THE MARYLAND-NATIONAL CAPITAL PARK AND PLANNING COMMISSION

## MEMORANDUM

**REVIEW TYPE:** Special Protection Area – Final Water Quality Plan and Site Plan Review  
**APPLYING FOR:** Approval of 486 Units (328 SFD, 109 TH's and 49 MPDU townhouses) on 164 acres  
**PROJECT NAME:** Greenway Village at Clarksburg – Phases 1 and 2  
**CASE #:** 8-02036  
**REVIEW BASIS:** Sec. 59-D-3, M. C. Zoning Ordinance

**MODIFIED MONTGOMERY COUNTY STANDARD NO. MC-211.01**  
**SECONDARY RESIDENTIAL ROAD**

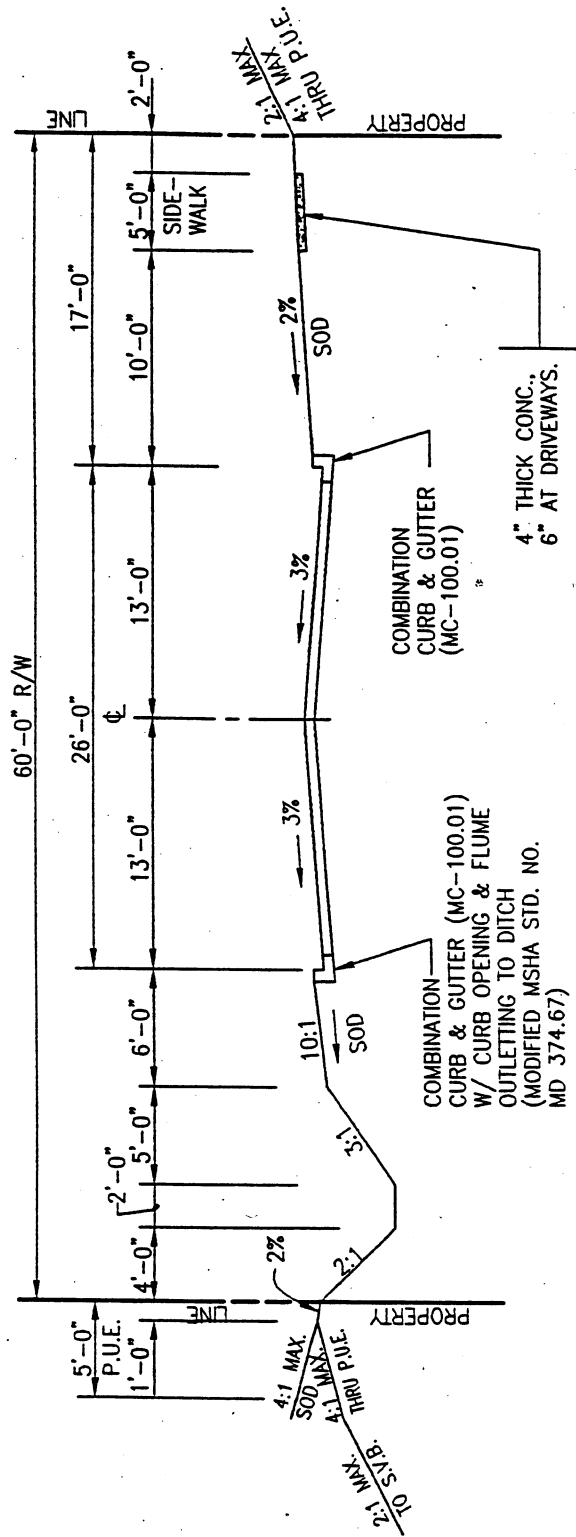
*MCDPW&T accepts the use of the  
modified sections type 12 and 17,  
and all other standard sections  
shown on sheet 27 of 27  
dated August 23, 2002.*
